Subject: USNRC Docket No. 72-1014; TAC No. L22221
HI-STORM 100 Storage Application
Resolution of Public Comments

In response to your request, we are pleased to enclose herewith draft copies of change pages comprising proposed Revision 10 to the HI-STORM 100 Topical Safety Analysis Report (TSAR). The proposed changes are identified with revision bars in the margin. These changes include those discussed with the NRC in a conference call held on January 28, 2000 to address public comments received during rulemaking as well as other minor editorial changes and clarifications. Please note that changes to drawings are not included with this submittal as discussed with the NRC project manager previously.

DRAFT PROPOSED REVISION 10

HI-STORM TSAR CHANGES

FIG. 3.A.19 Tipover Scenario: Impact Force Time Histories

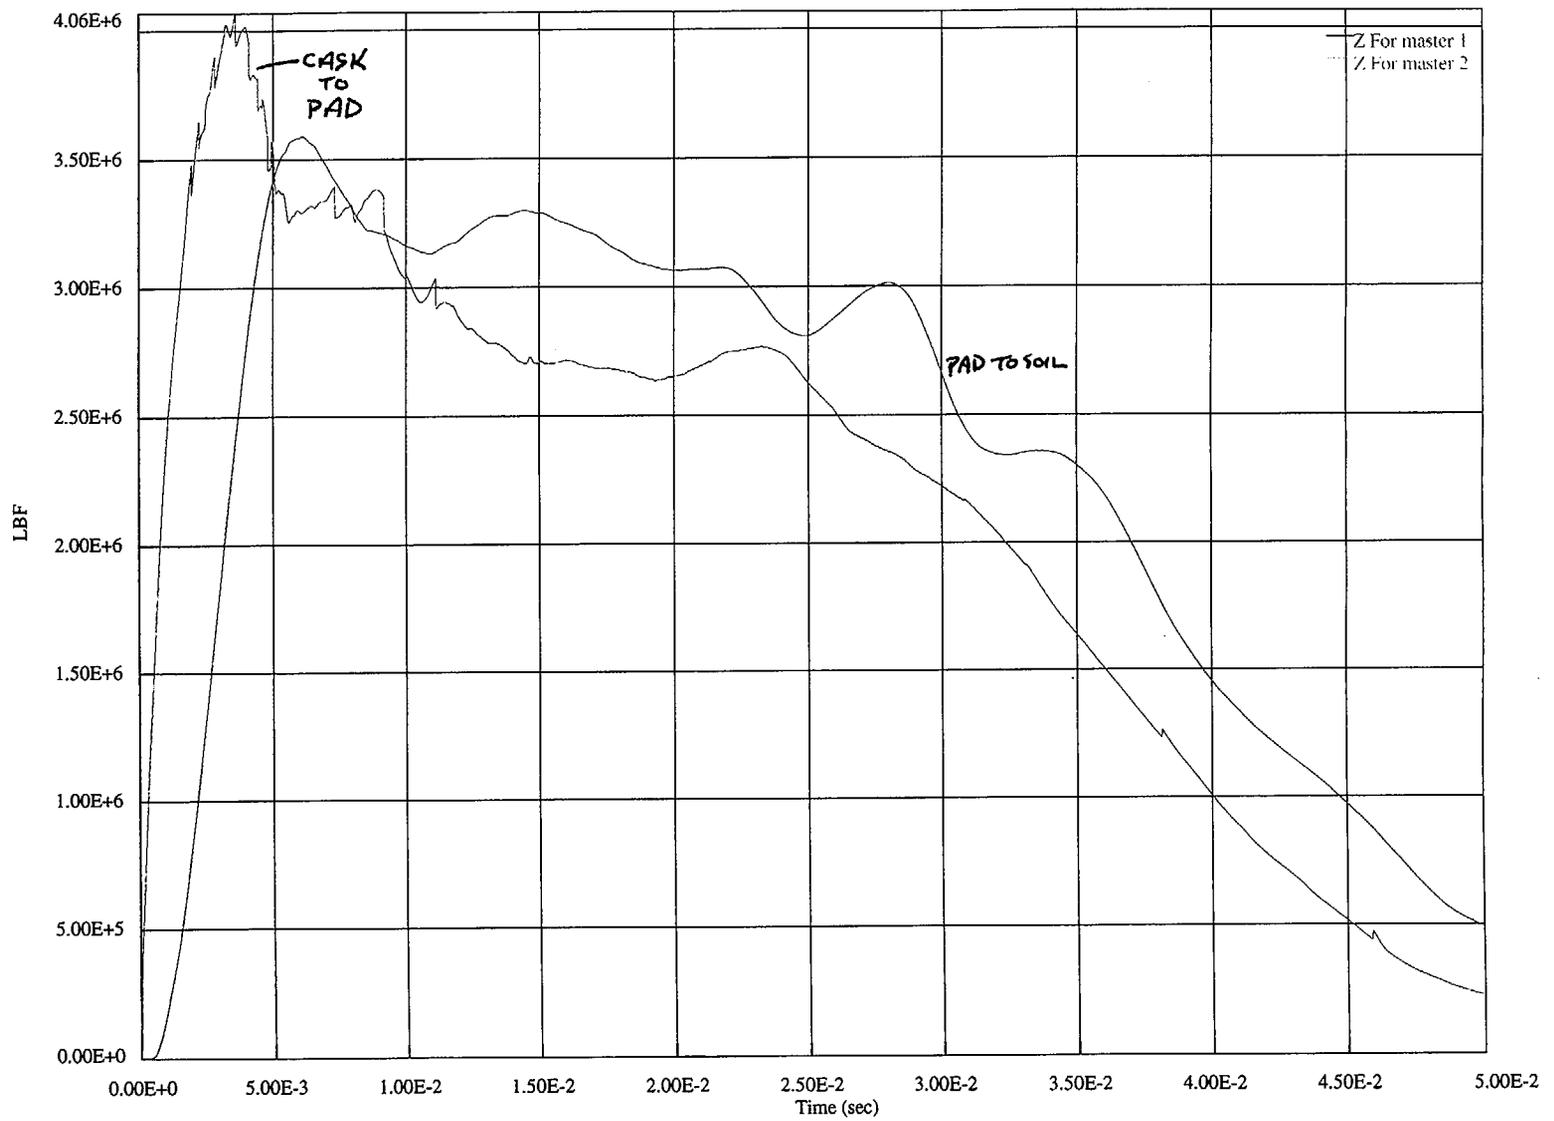
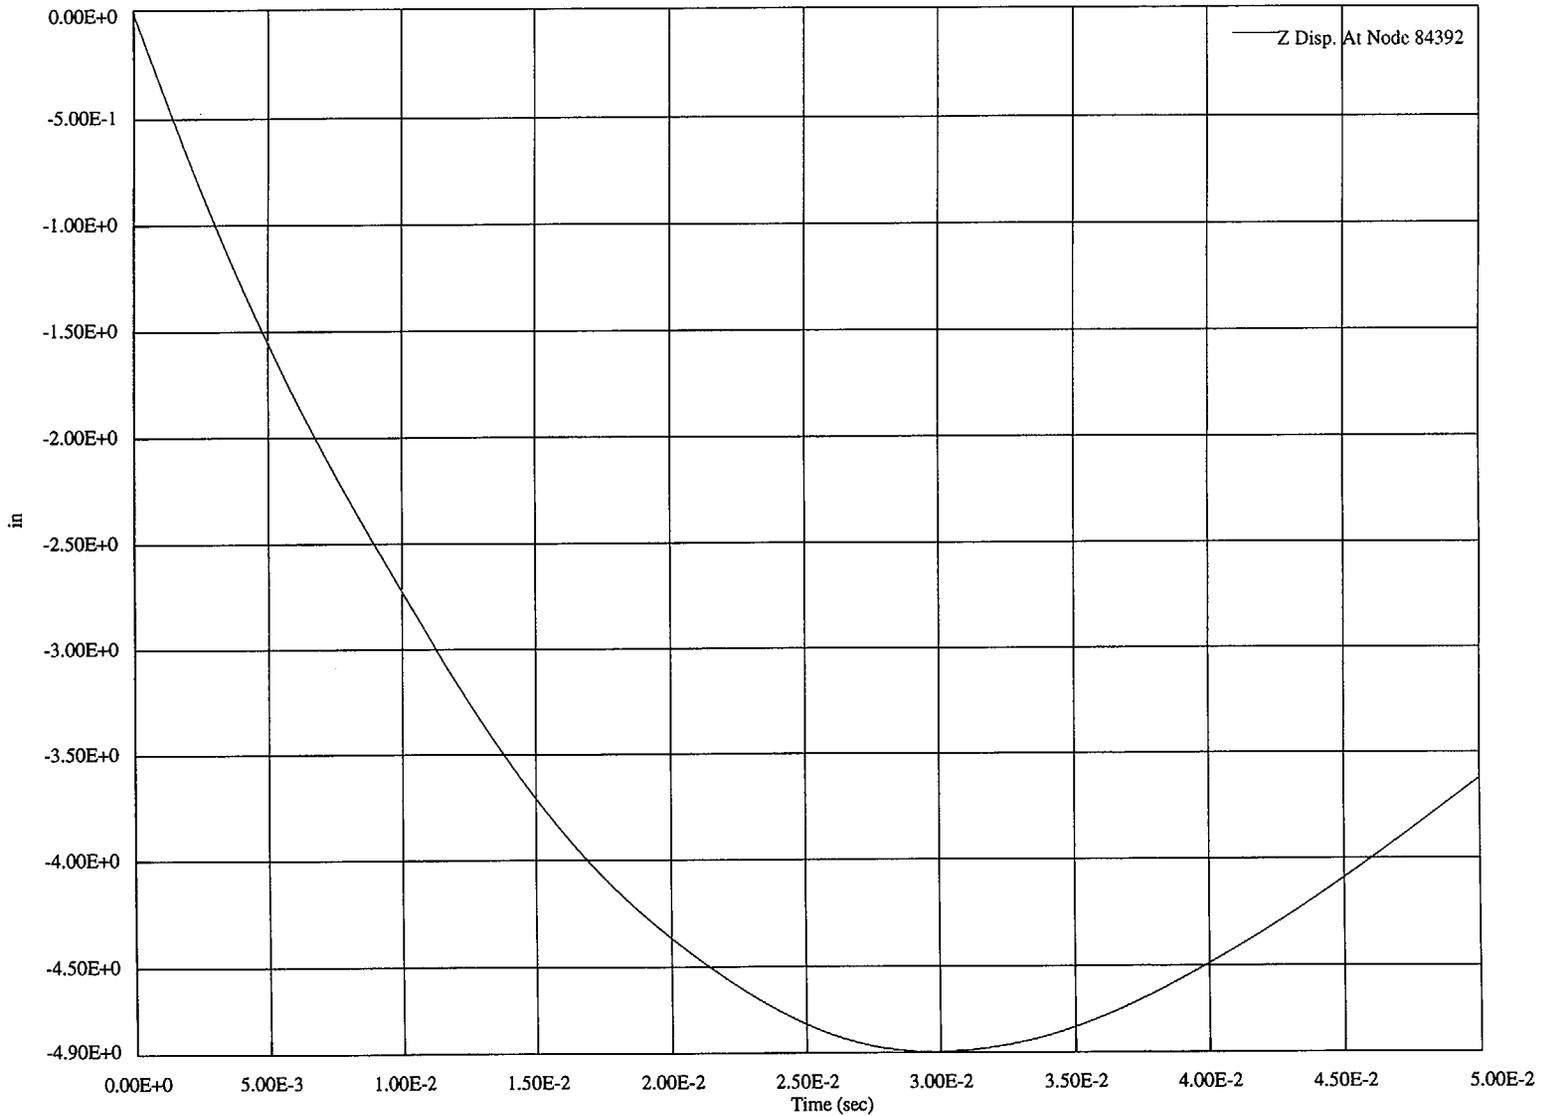
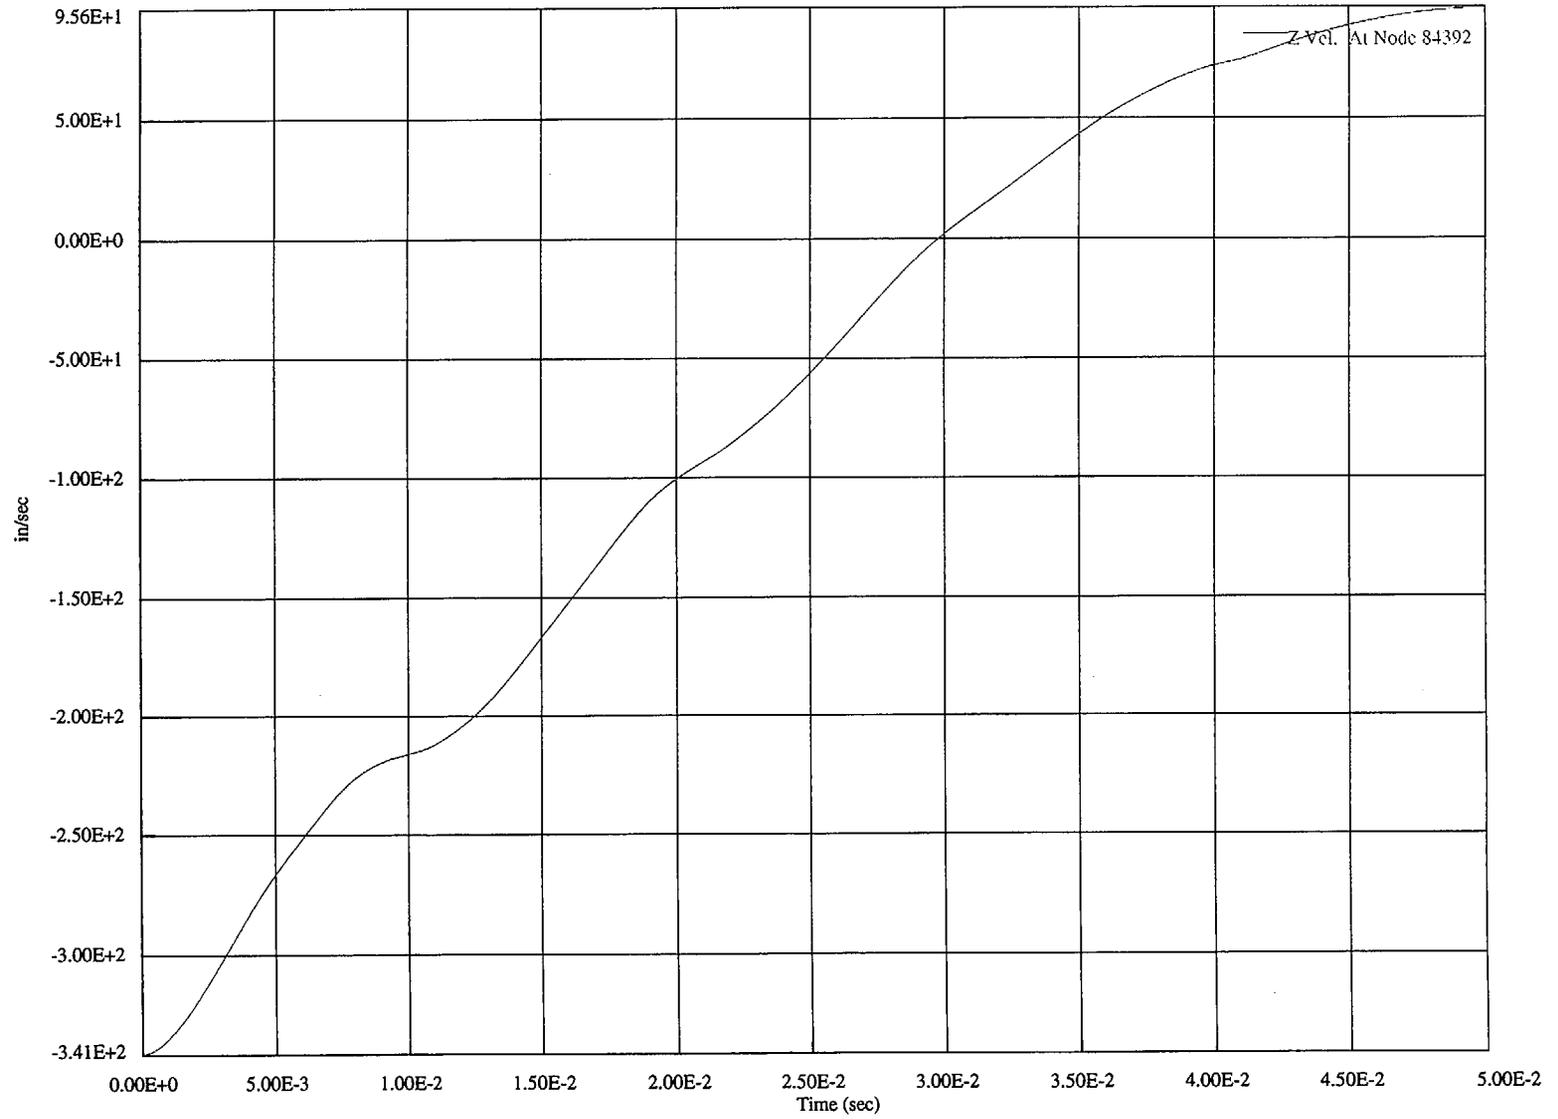
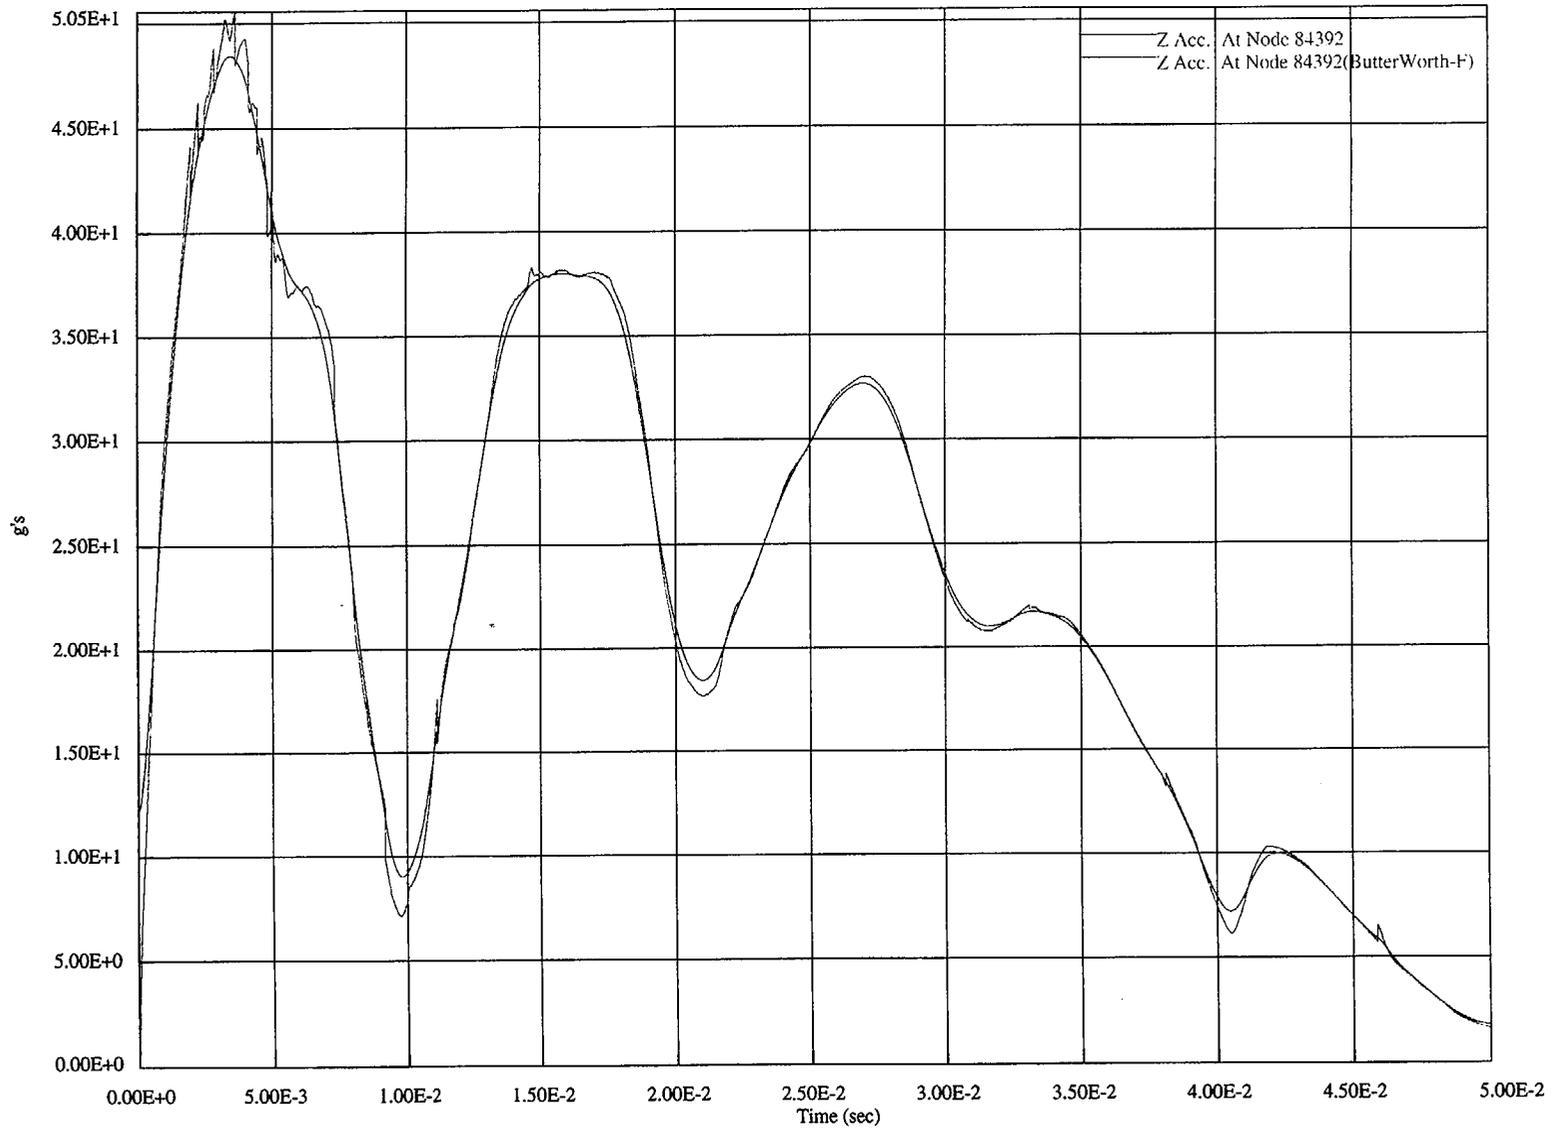
In the interest of absolute technical accuracy, we have also revised the results of the cask tip-over events in TSAR Table 3.A.4 even though the deceleration values change only in the second decimal place. Recent discovery of a data input discrepancy in the LS-DYNA3D input file led us to re-run the tip-over cases which, as proposed revised Table 3.A.4 shows, produced infinitesimal changes in the results. Associated TSAR Figures 3.A.19 through 22 are also proposed to be replaced.
